HIGHLAND CITY DEVELOPMENT ADMINISTRATION BOARD AGENDA

DEVELOPMENT ADMINISTRATION BOARD AGENDA REPORT ITEM #2

DATE: April 11, 2024
TO: Development Administration Board
FROM: Rob Patterson, City Attorney / Planning & Zoning Administrator
SUBJECT: **Final Plat Approval:** Foxwood Estates
TYPE: **LAND USE (ADMINISTRATIVE)**

Foxwood Estates Subdivision

Sheet No.
C - 18

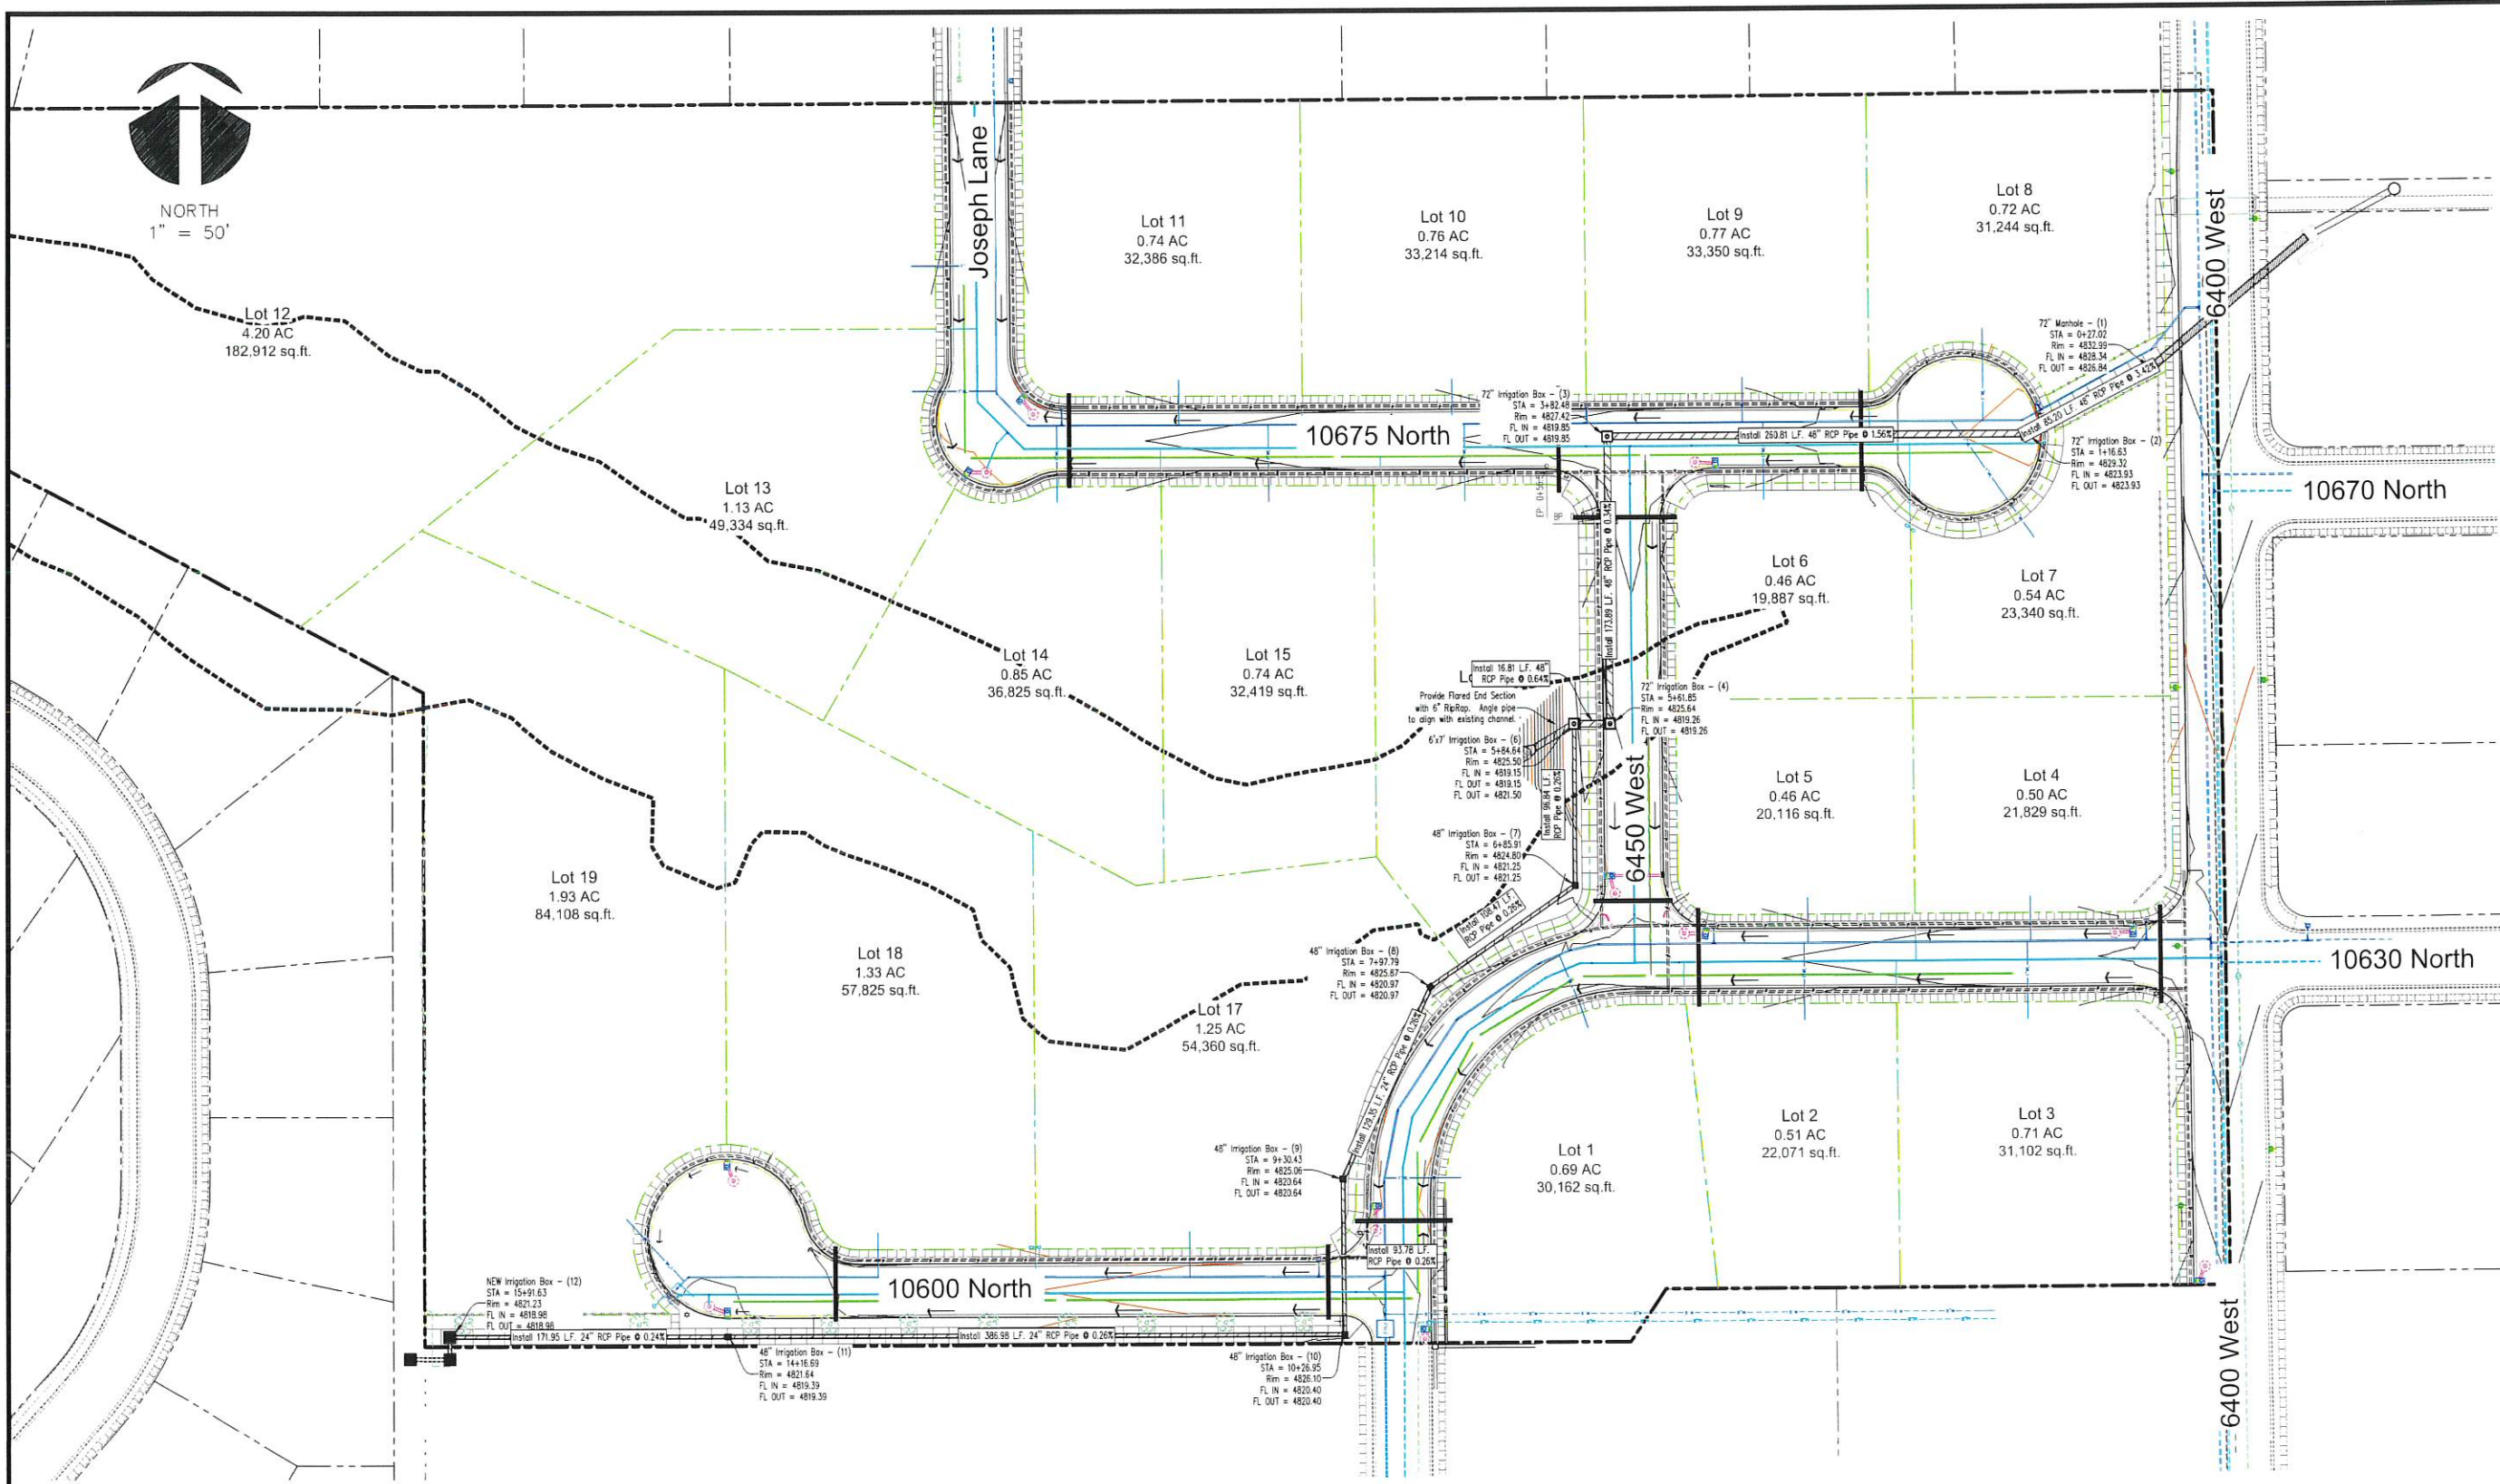
Sheet C-18:
